MICHIGAN DEPARTMENT OF ENVIRONMENTAL QUALITY
PERMIT

Permit No. 02-37-0003-P
Issued July 3, 2002
Extended
Revised
Expires December 31, 2003

Remove an existing dam, construct 5 rock weirs, construct 3 canoe landings, construct pathways, construct a pedestrian bridge and place riprap and 2,573 cubic yards of fill within the Chippewa River and the floodplain of the Chippewa River as shown on the attached plans.

CHIPPEWA RIVER RESTORATION PROJECT
CITY OF MT. PLEASANT, MICHIGAN
PERMIT APPLICATION SUPPLEMENTAL INFORMATION
MDEQ FILE NO. 02-37-0003-P
Prepared by Wilcox Professional Services, LLC, April 12, 2002

ATTACHMENT 1

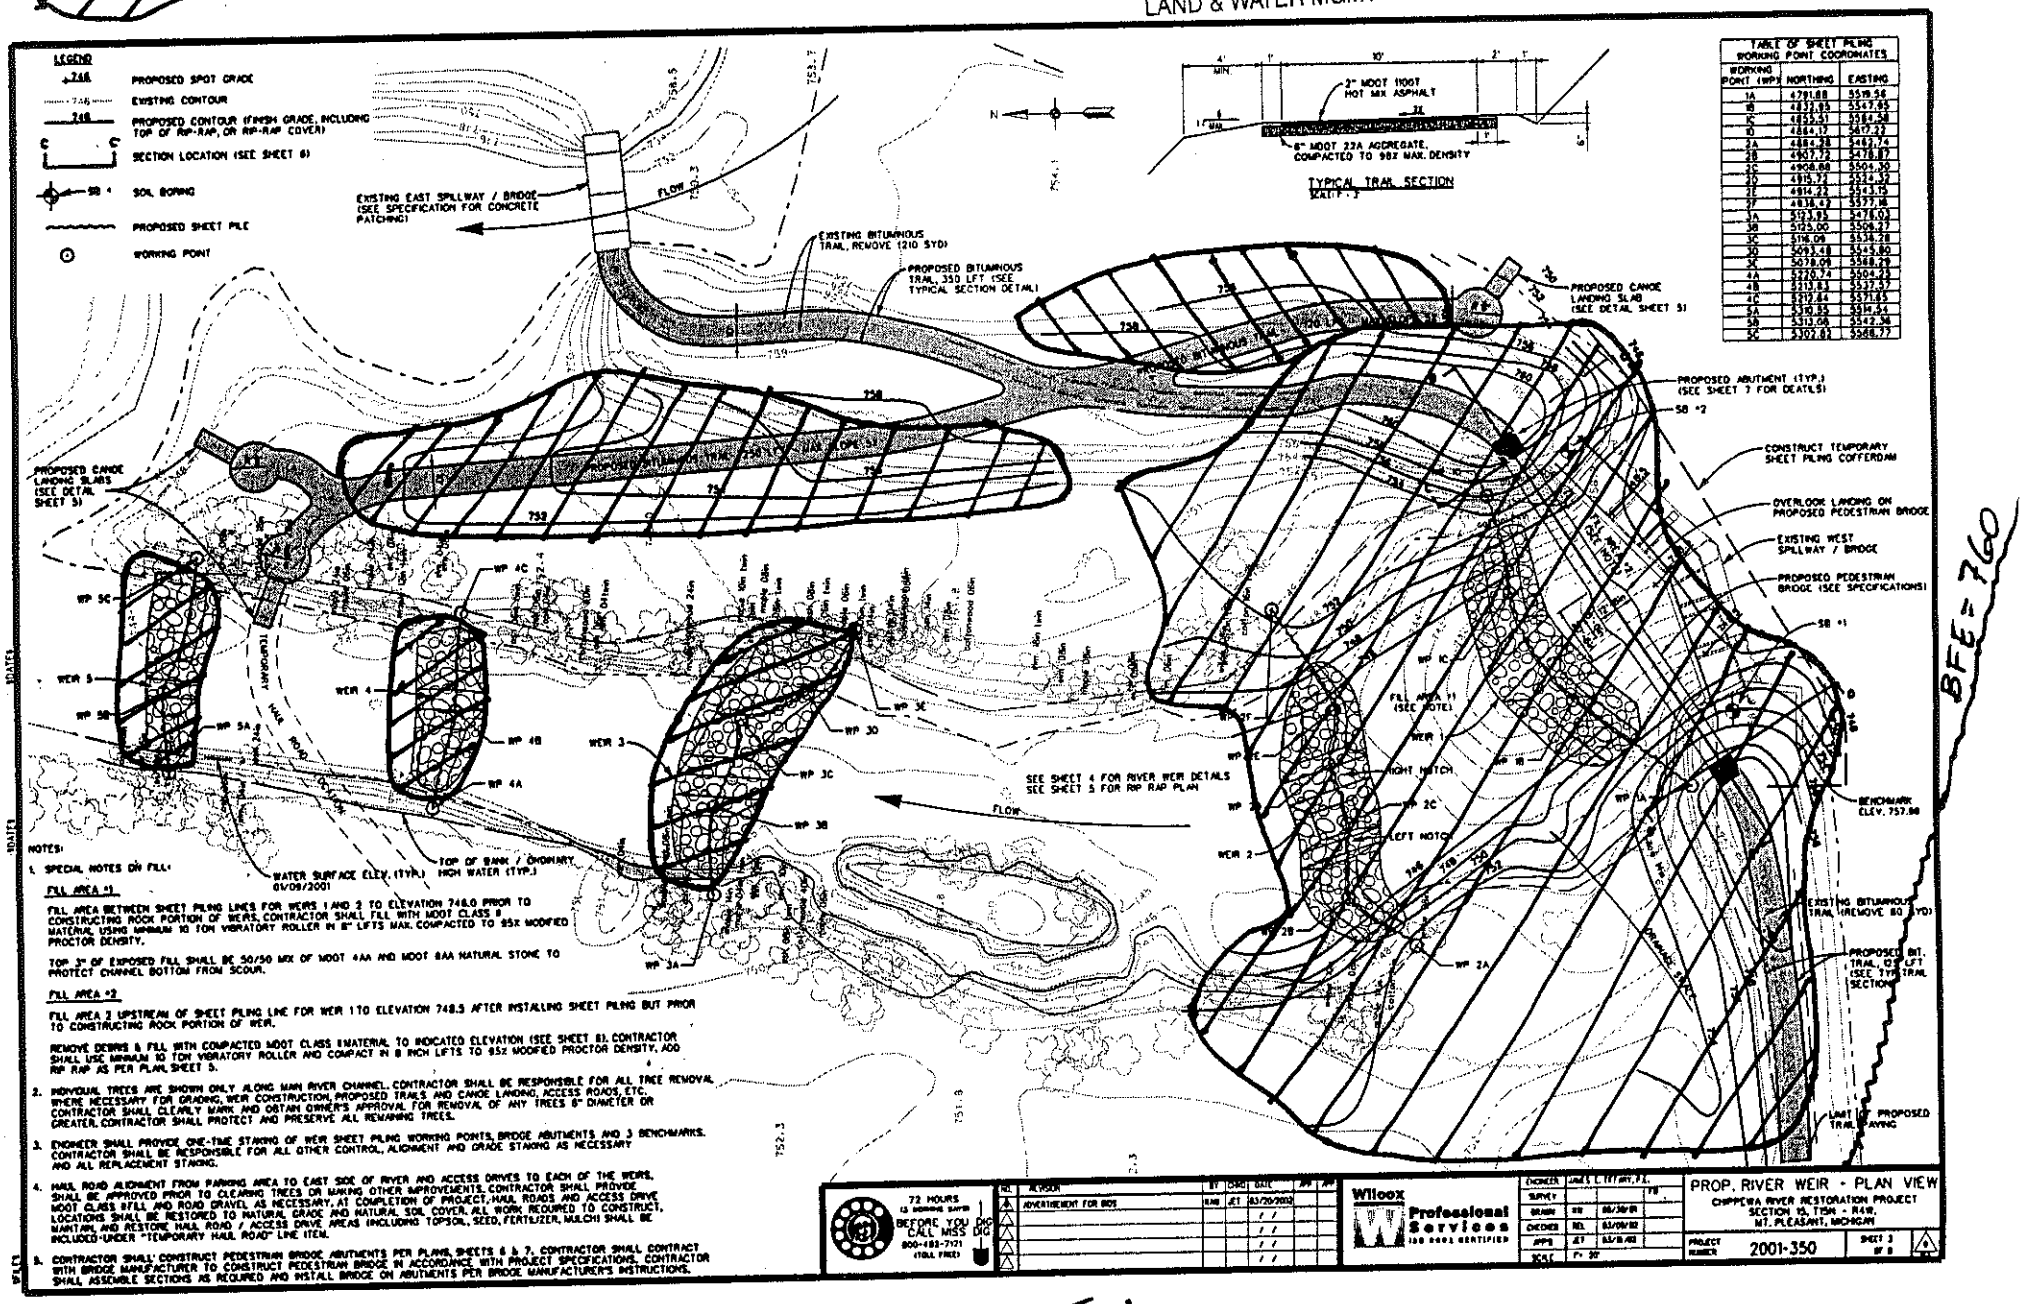
(3) a. project site plan that shows the floodplain boundaries and elevations (if known), and shows all area of proposed floodplain fill and floodplain excavation (cross hatched or shaded)

The areas of cuts and fills are shown in Attachment 1 along with base flood elevations. It is important to note that all project cuts and fills will be in the floodplain.
